**RE: R+L Carriers Maintenance Bldg  
2381 Aztec Rd NE  
Grading and Drainage Plans  
Engineer's Stamp Date: 12/29/23  
Hydrology File: G16D092**

RE: R+L Carriers Maintenance, 2381 Aztec Rd NE  
Grading and Drainage Plan  
Engineer's Stamp Date: No Date  
Hydrology File: G16D092

In response to your review letter dated November 16, 2023, we offer the following responses, in ***bold and italics***, to the outstanding comments:

**EX4**

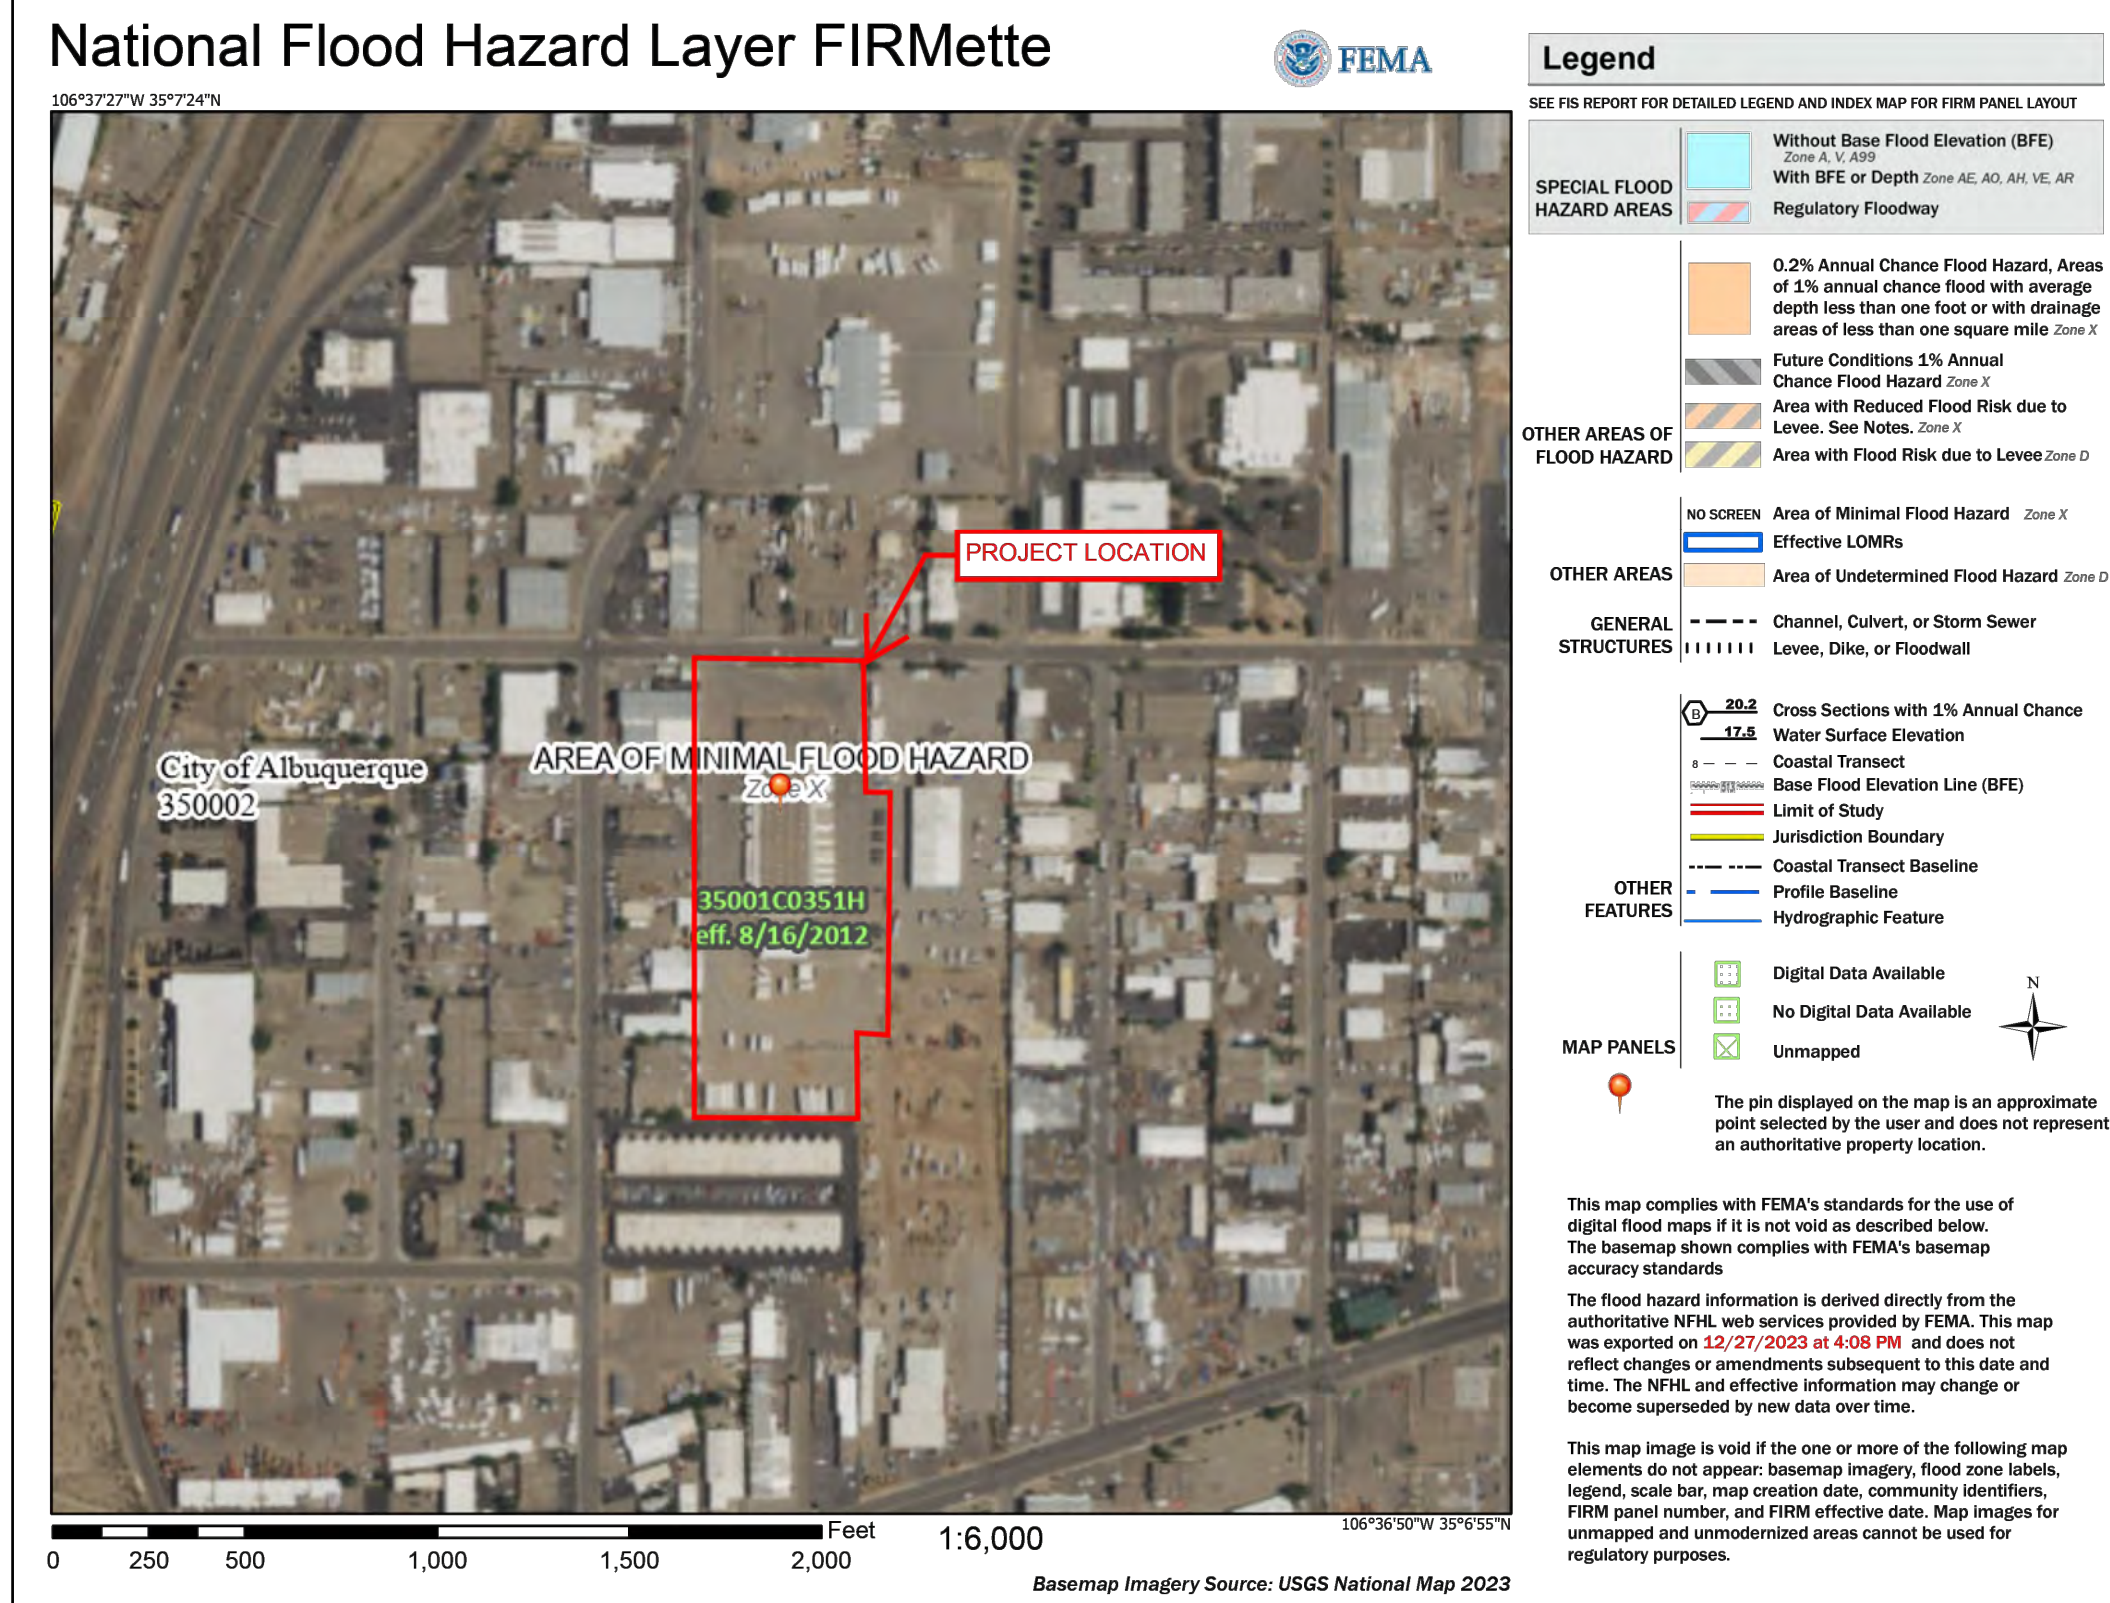
- c. Please provide a Vicinity Map. Typically, this is the Zone Atlas. This can be downloaded from the City of Albuquerque's website.

- e. Please provide FIRM Map and flood plain note with effective date.

4. The narratives and drainage calculations look great. However, they are a little bit out of focus and hard to read. Since the projects appears to need two sheets, please fix so that they are more readable.

***Response: The Vicinity Map has been added to the Grading and Drainage Plan Exhibit, please see sheet EX4.***

***Response: The FIRM Map with flood plain note and effective date has been added to the Grading and Drainage Plan Exhibit, please see sheet EX4.***

**Response: The narrative and calculations have been fixed so they are readable, please see sheet EX4.**
